February 10, 2025

Subject: Review of Septic Plans for 41 North Main Street, Sherborn, MA – Pine Residence

Figure 2 – Hydraulic Flow from Proposed Septic and Existing Septic.

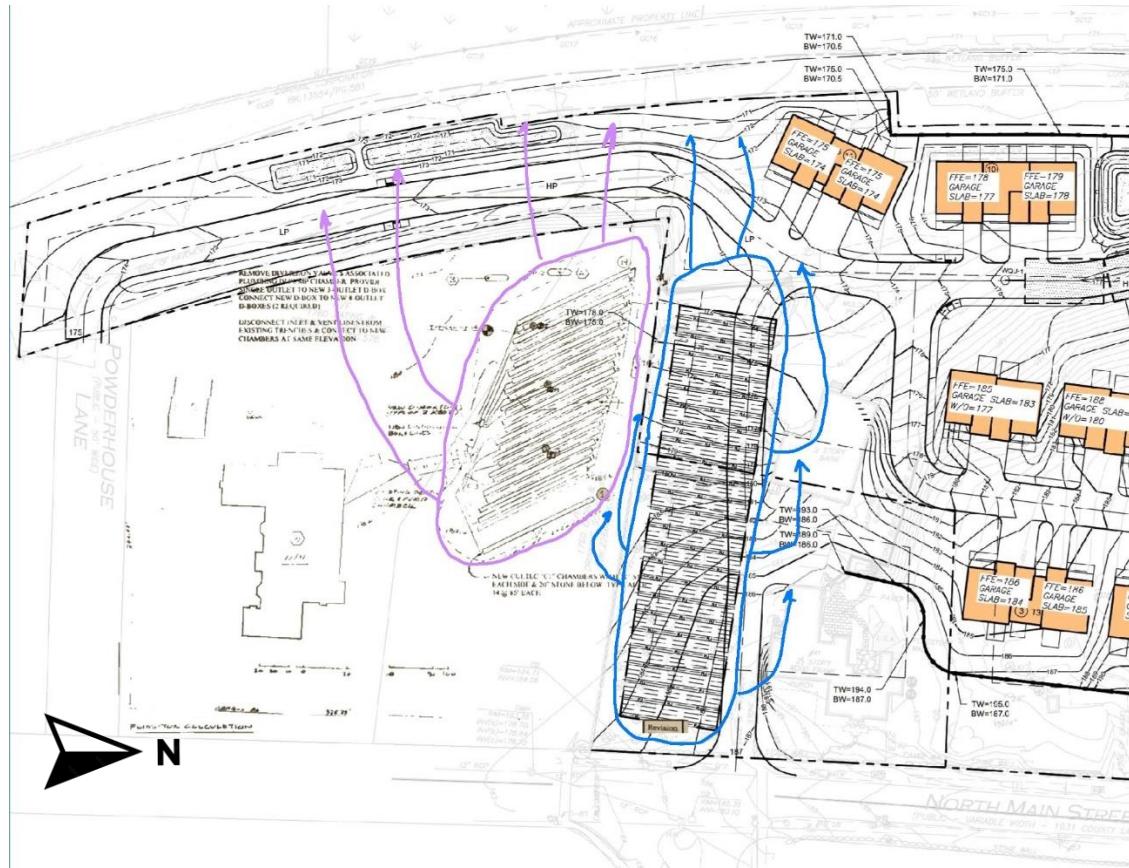
The septic system for 33 North Main Street is located about 170 to the north of the well along the property line of 41 North Main Street. The proposed septic system for 41 north Main Street is located at minimum of 260 feet from the well at 33 North Main Street.

Water used at the Tavern is returned to the shallow aquifer recharging the water table through the septic system. When septic is delivered to the septic system localized mounding of the water table in the area of the septic system occurs. Water mounding creates a hydraulic dam or virtual water wall in the area of the 33 North Main Street septic system which is along the property line with 41 North Main Street.

Figure 3a and 3b – Soil Test Pit Locations and Data

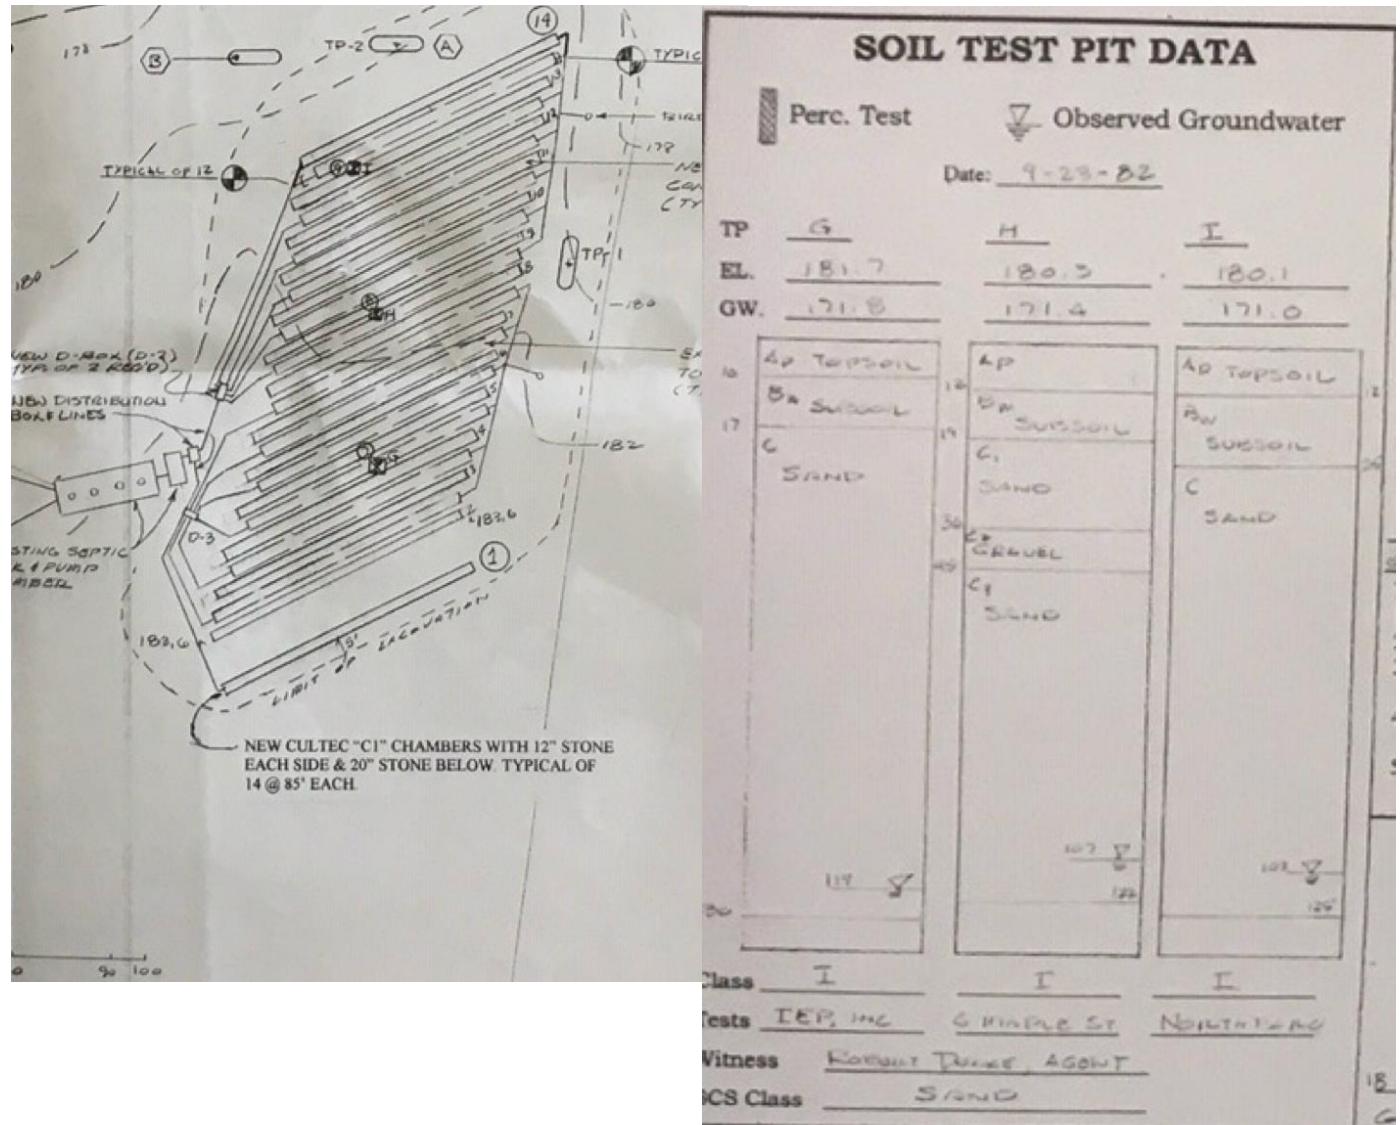
A review of the test holes conducted during the design of the septic for 33 North Main Street, it is determined that water flows east to west across both properties from North Main Street towards the railroad tracks at a slope of 0.009 feet vertical per foot horizontal. Test pit data and locations are shown on Figures 3a and 3b.

The Town of Sherborn has restricted the use of the property at 41 North Main Street based on the IWPA and their local bylaw. They are restricting the septic design for 41 North Main Street along the shared property line with 33 North Main Street due to an assumption of nitrogen loading. As shown, most if not all of the water discharged in the proposed septic at 41 North Main Street will flow towards the railroad track.
